Rev. 3

EM-225A

POST ACCIDENT RB HYDROGEN CONTROL

Procedure: EM0225A

ACCESS ROUTES

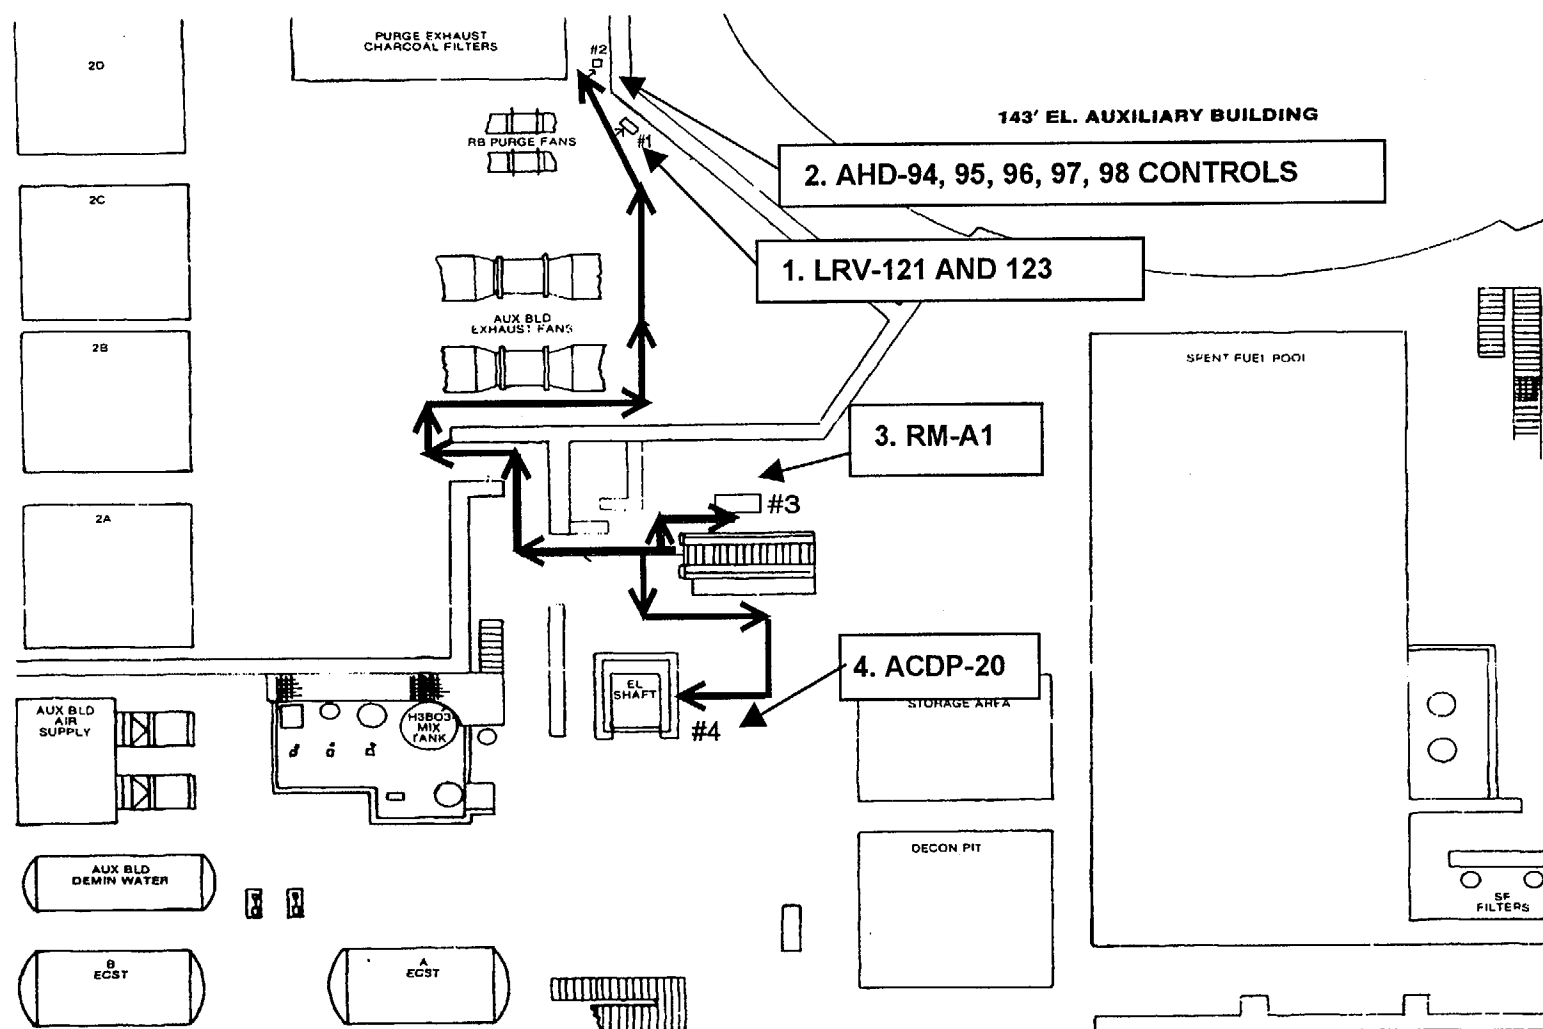
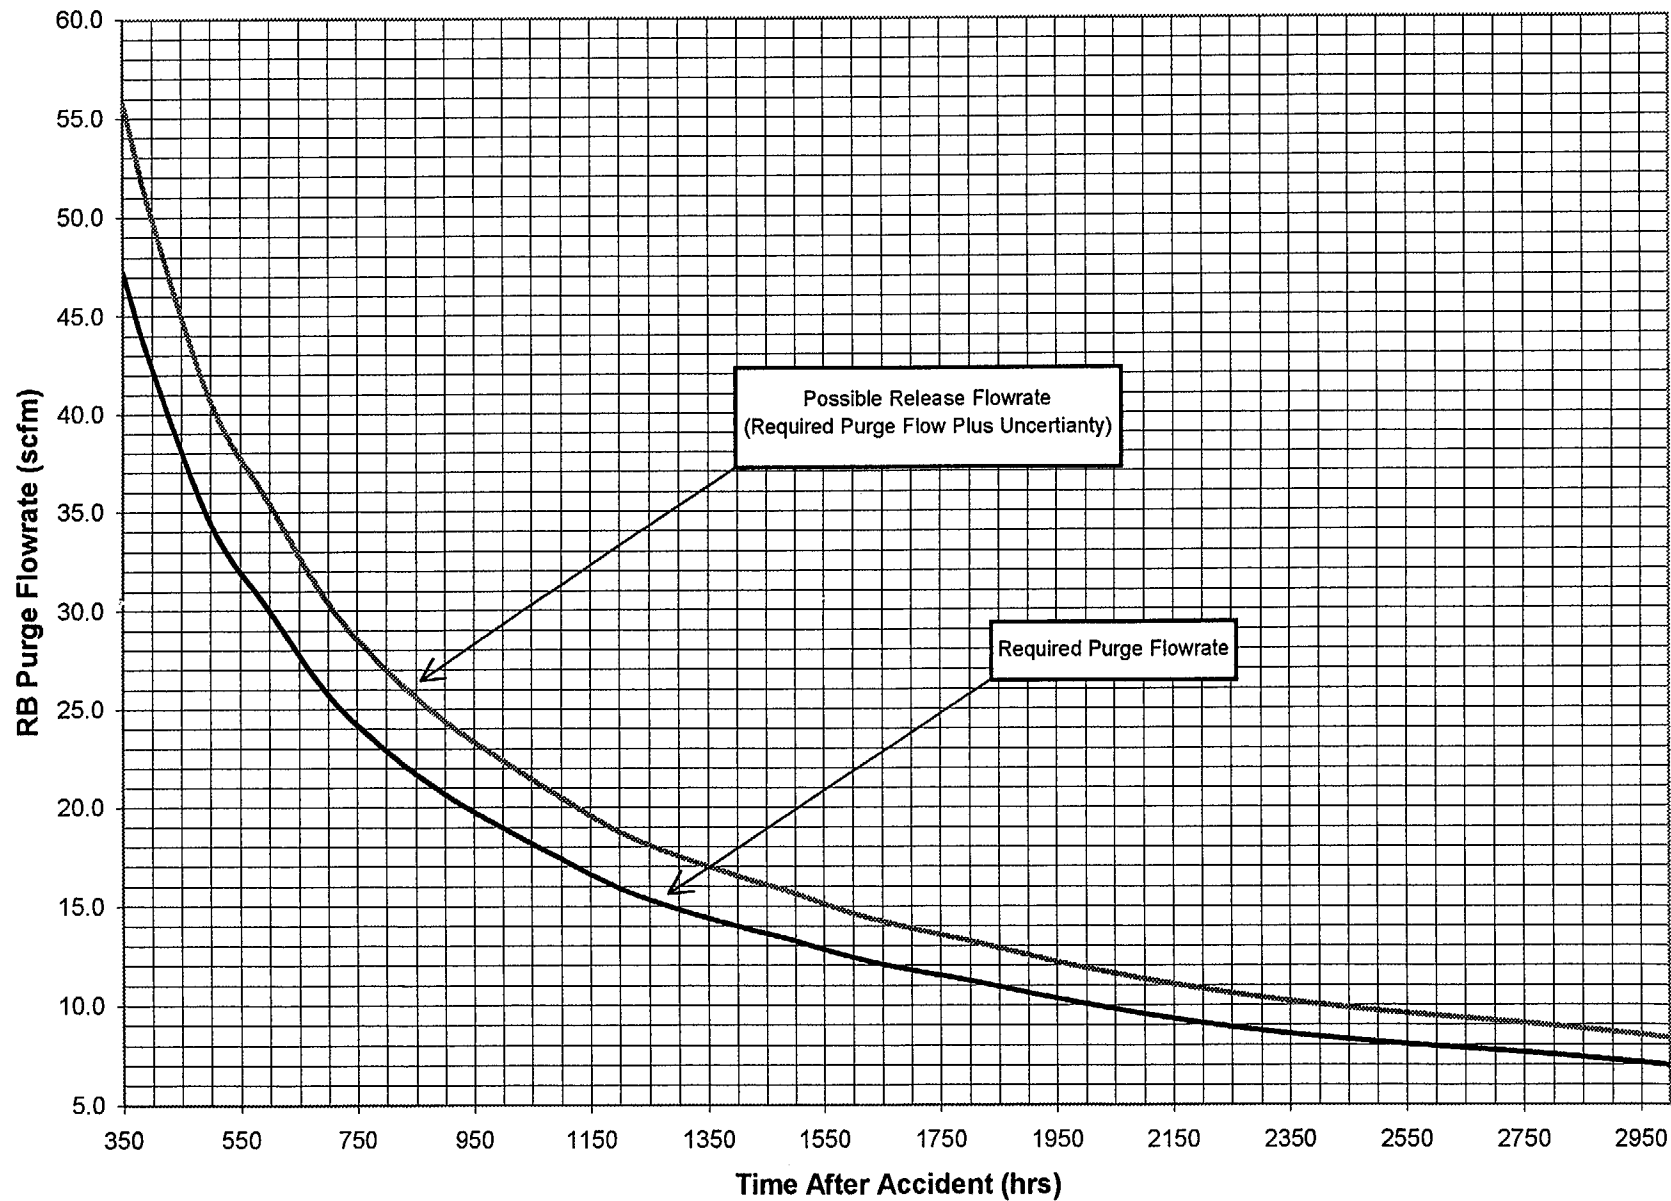
Enhanced the locations of the equipment and access routes to make it less confusing and more pronounced.
